CITY OF ALBUQUERQUE

**RE: WALH Towne Center Mass Grading
Grading Plan
Engineer's Stamp Date: 10/25/17
Hydrology File: J08D004**

Based on the information provided in the submittal received on 10/26/17 the above-referenced Grading Plan cannot be approved for Grading Permit until the following conditions are met:

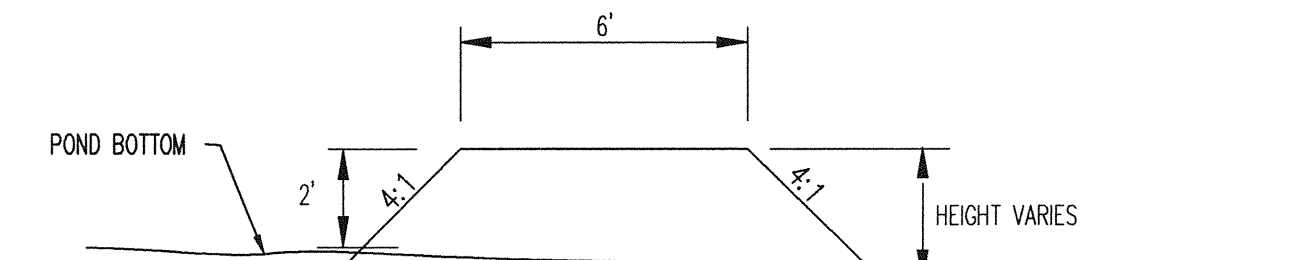
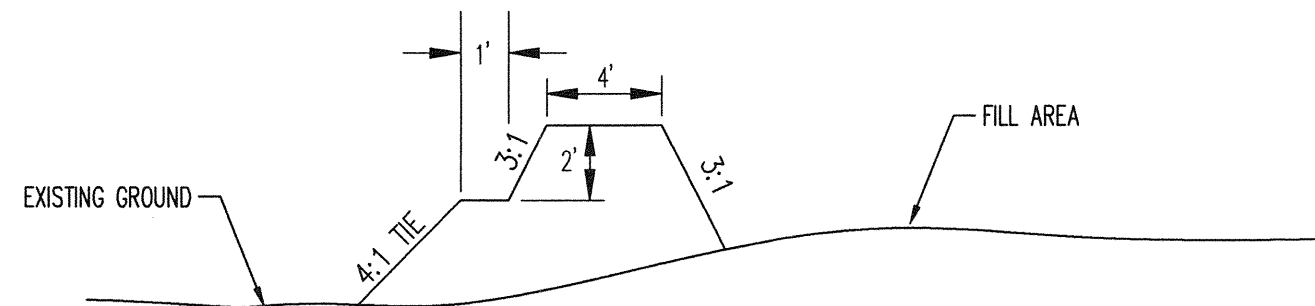
1. Section views A-A and B-B need to clearly define existing grade, fill, and compacted berm.
2. Compaction needs to be to 95%, extend to the subgrade, and include subgrade prep.
3. A maintenance plan needs to be included on the grading plan and include: inspections and interval, vector control, mowing, sediment removal, erosion repair, etc.
4. A Bernalillo County Recorded Private Facility Drainage Covenant is required for the ponds and maintenance of the stockpile. Please contact Charlotte LaBadie (clabadie@cabq.gov, 924-3996) or Madeline Carruthers (mtafoya@cabq.gov, 924-3997) regarding the routing and recording process for covenants.
